Millstone Nuclear Power Station, Unit No. 2
ASME Section XI Request (RR-89-34, Revision 1), Use of Alternative to Weld Repair
Requirements and Relief Request (RR-89-36), Characterization and Successive
Examinations of Remaining Flaws in Reactor Vessel Head Penetrations
(TAC No. MB 4223)

Response to Request For Additional Information

Request RR-89-34 (Revision 1)
Use of Alternative to Weld Repair Requirements for
Reactor Vessel Head Penetration Nozzles

CEDM TEMPERBEAD WELD REPAIR AREAS TO BE EXAMINED

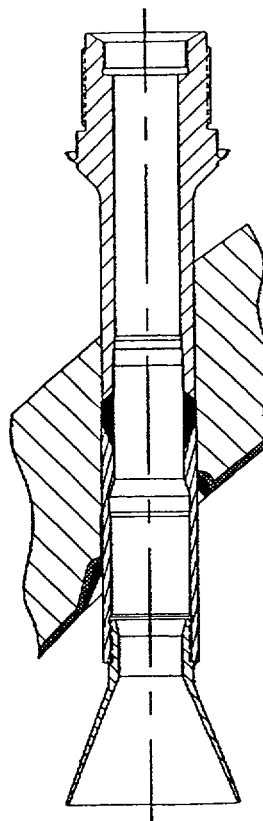
- a. *Provide sketches showing the area that will be surface inspected prior to welding and after welding. Indicate any differences in the inspection areas (from Code requirements) for the instrument nozzles, header vents, and CRDM nozzles*

See RR-89-34 in Attachment 2, Enclosure 1, Section 4.0, entitled Examination. The areas to be surface examined prior to welding consists of the machined bore of the vessel head penetration and the weld bevel plus $\frac{1}{2}$ " of the nozzle base material. (See figure 3 in Attachment 2.) The final weld surface examination will consist of the weld plus $\frac{1}{2}$ " of base material on each side of the weld.

FIGURE 3:
OVERVIEW OF
REPAIR TECHNIQUE

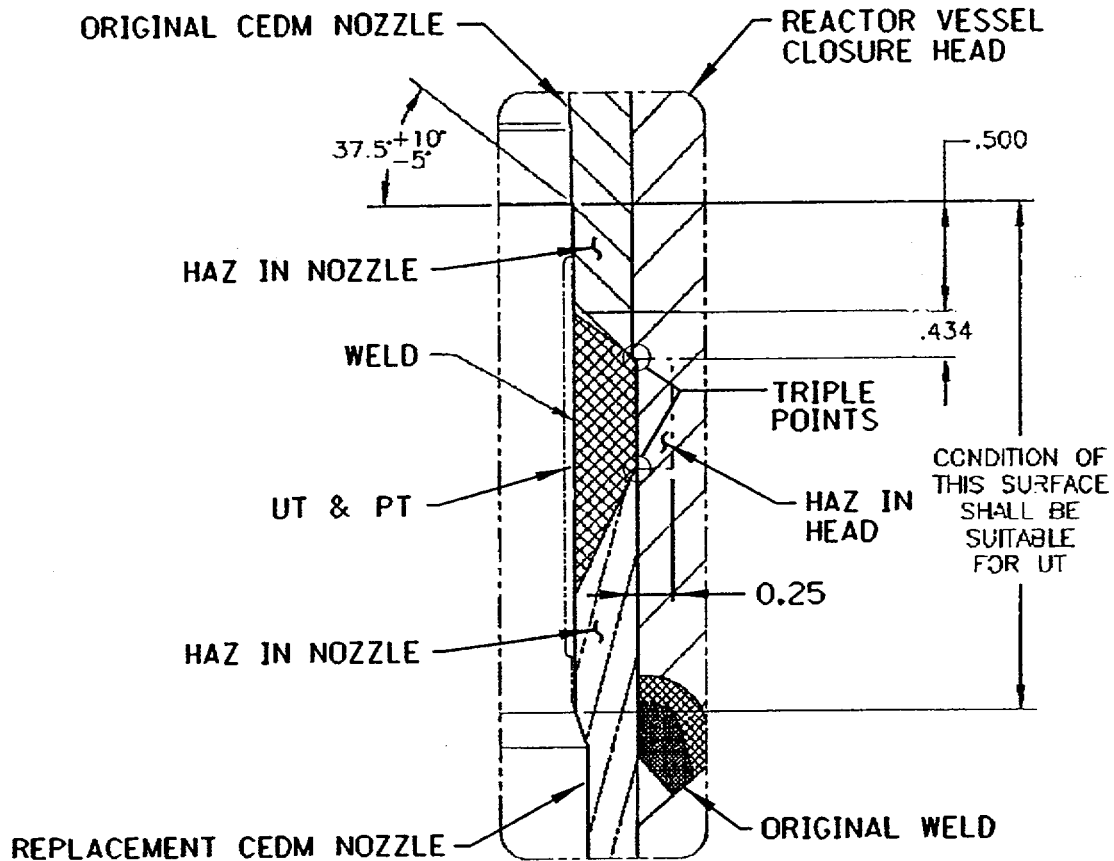
The relief request shall show details of each type of repair to be made for each weld process to be used.

See RR-89-34 in Attachment 2, Figure 3 for an overview of the repair process.

- 10) UT will be performed in lieu of RT due to the repair weld configuration. Meaningful RT cannot be performed as can be seen in Figure 3. The weld configuration and geometry of the penetration in the head provide an obstruction for the x-ray path and interpretation would be very difficult. UT will be substituted for the RT and qualified to evaluate defects in the repair weld and at the base metal interface. This examination method is considered adequate and superior to RT for this geometry. The new structural weld is sized like a coaxial cylinder partial penetration weld. ASME Code Section III construction rules require progressive PT of partial penetration welds. The Section III original requirements for progressive PT were in lieu of volumetric examination. Volumetric examination is not practical for conventional partial penetration weld configurations. In this case the weld is suitable for both UT and PT.

FIGURE 4A through 4E: UT COVERAGE DETAILS

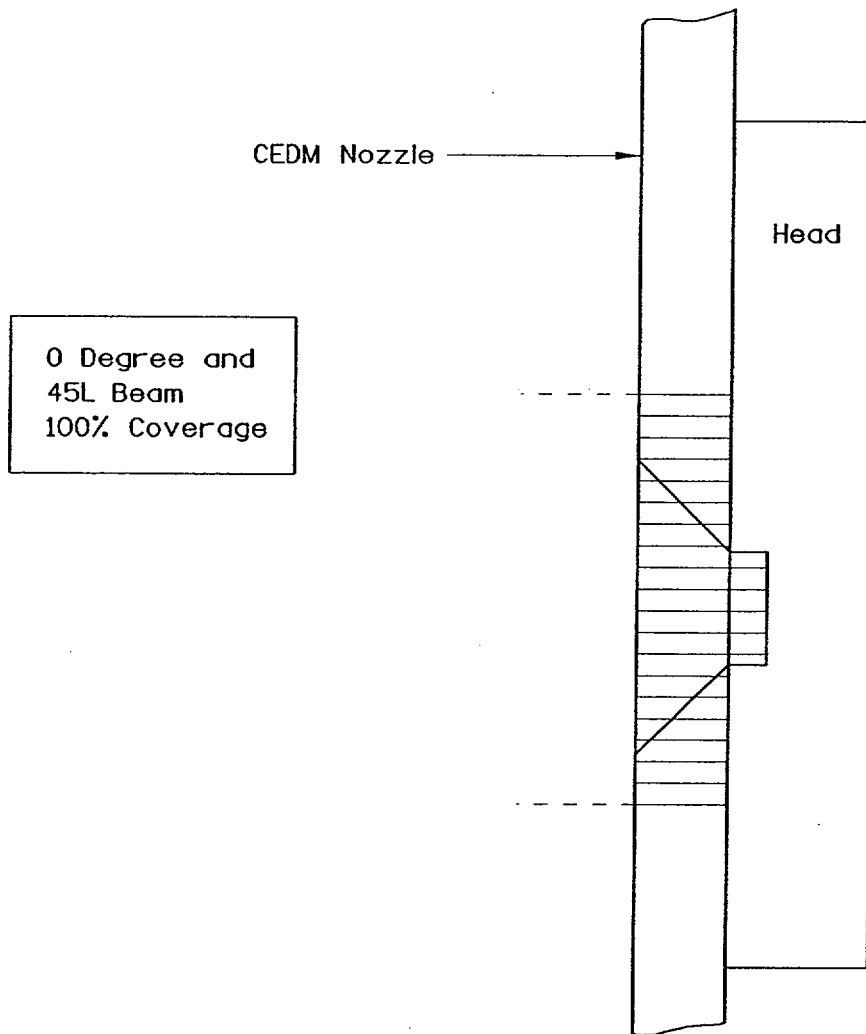
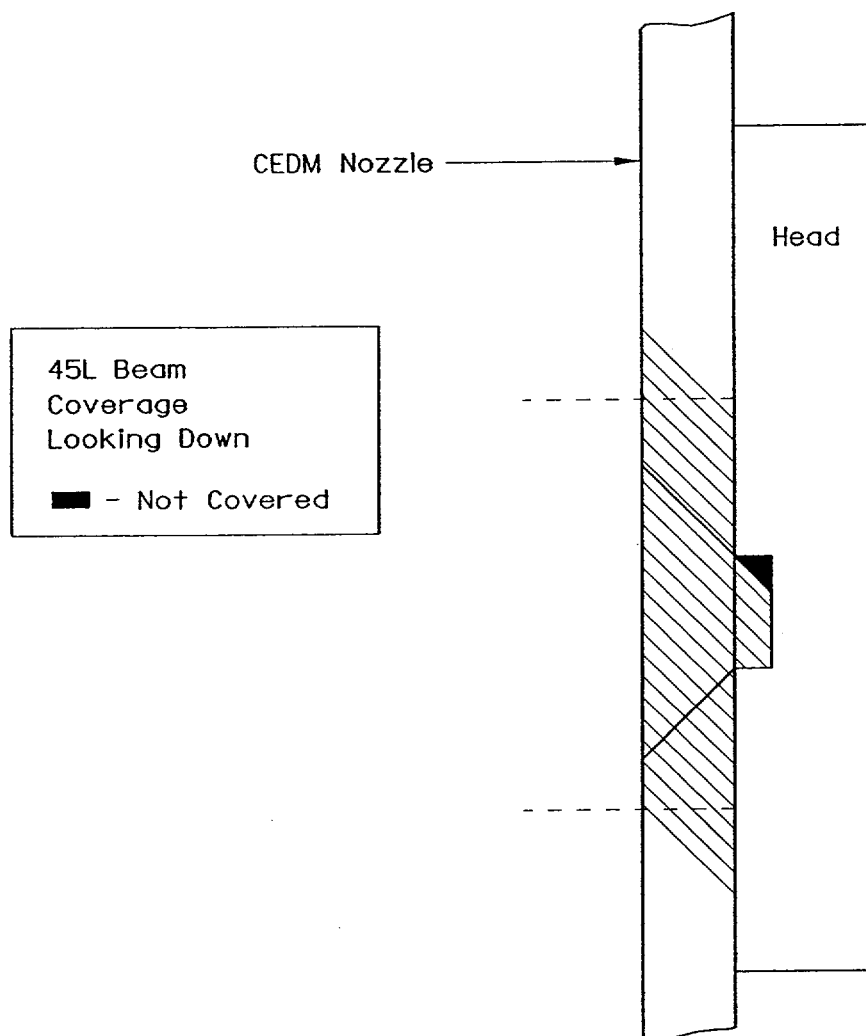
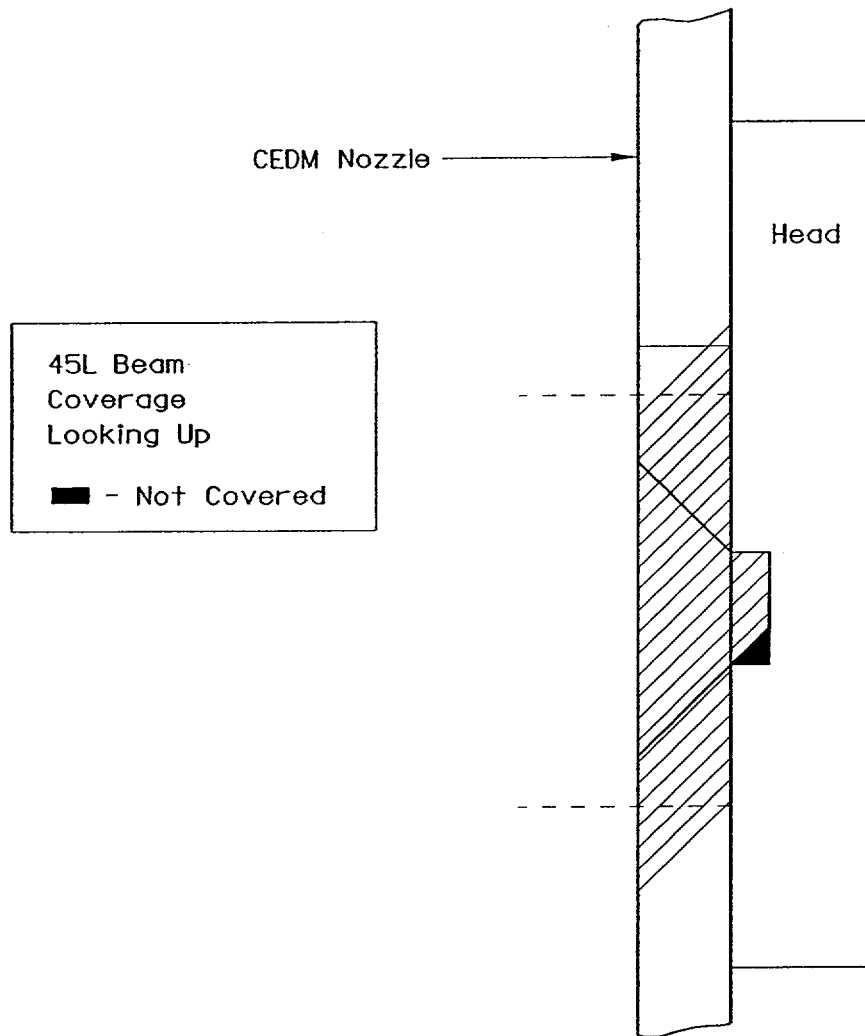
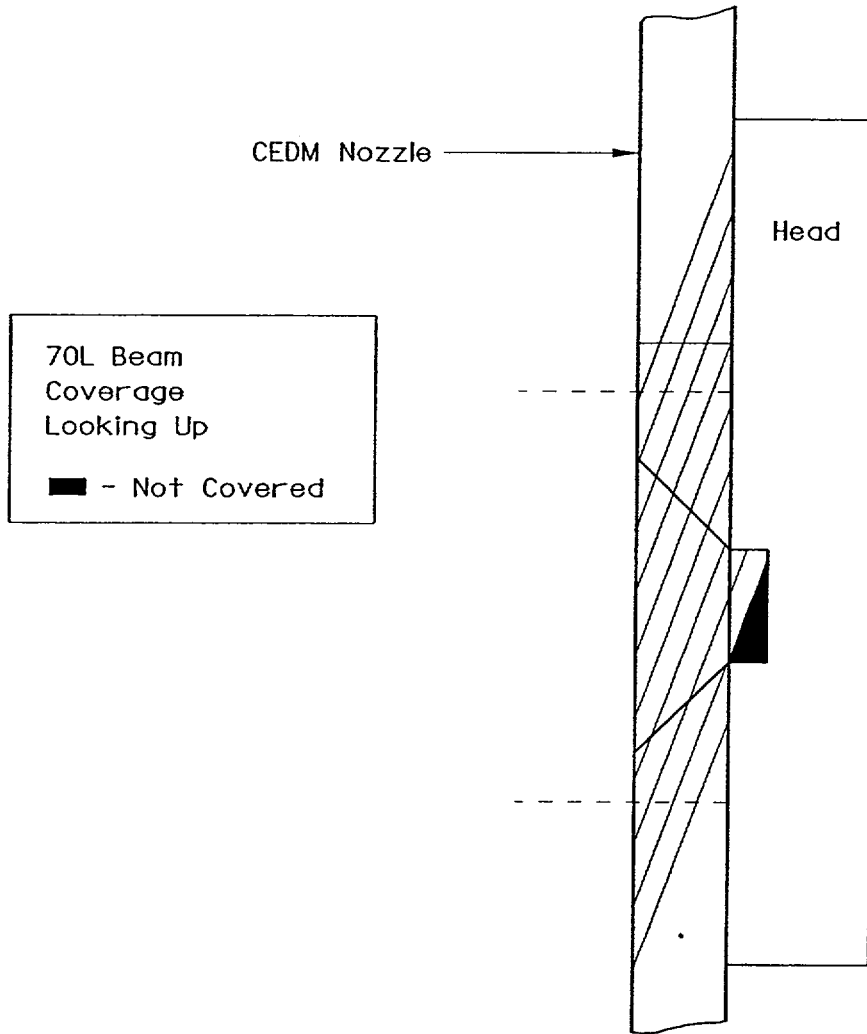
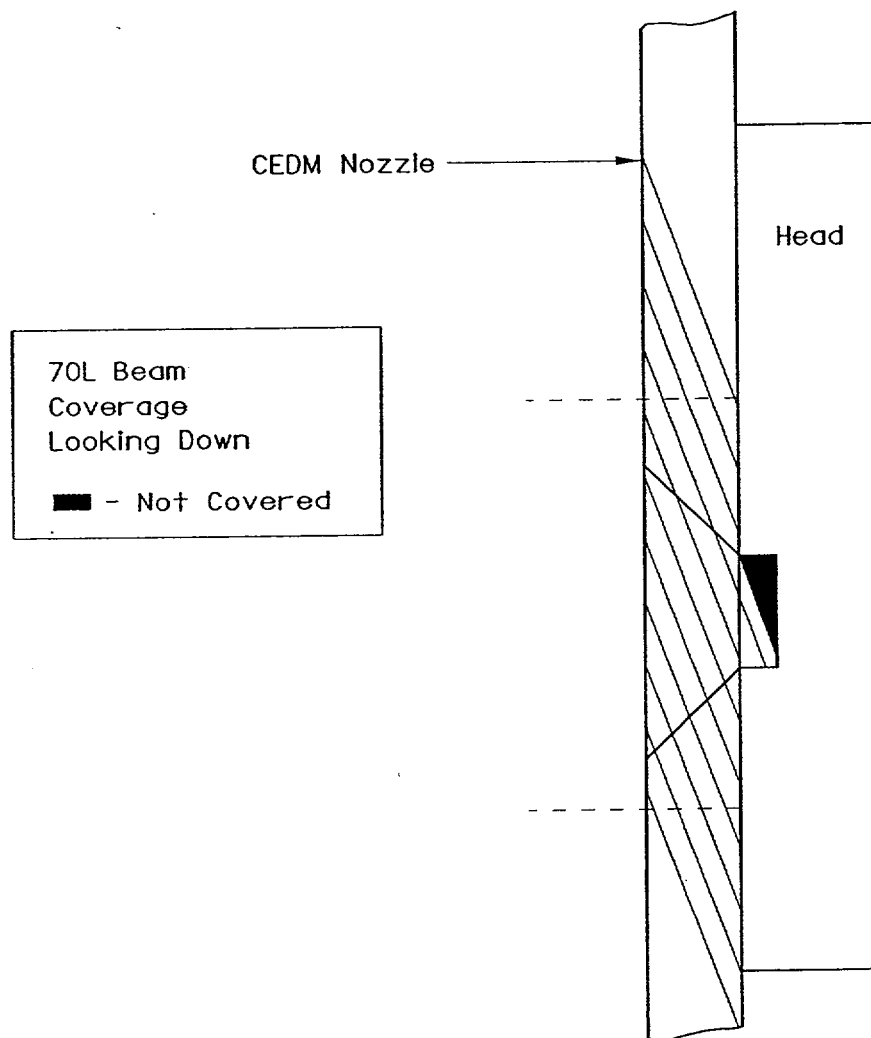
- b. *Provide sketches showing the examination surface and volume required by CODE for each inspection method and show the actual surface and volume that will be inspected. Describe the percent of coverage that will be achieved for each transducer and the total coverage for each repair.*

Refer to RR-89-34 in Attachment 2, Figure 4, and Figures 4a through 4e. The actual surface and volume that will be inspected is the same as that required by Code. The volume to be examined with UT consists of the full thickness of the weld plus $\frac{1}{4}$ " of head base material below the weld. In addition, $\frac{1}{2}$ " of nozzle base material will be examined on each side of the weld. Based on the repair weld design, the examination volume expected for each transducer, 0° L-wave, 45° L-wave Up, 45° L-wave Down, 70° L-wave Up, 70° L-wave Down, 45° L-wave Clockwise, and 45° L-wave Counter Clockwise is as shown in Figures 4a through 4e. The PT examination area will consist of the weld surface and $\frac{1}{2}$ inch on either side of the weld.
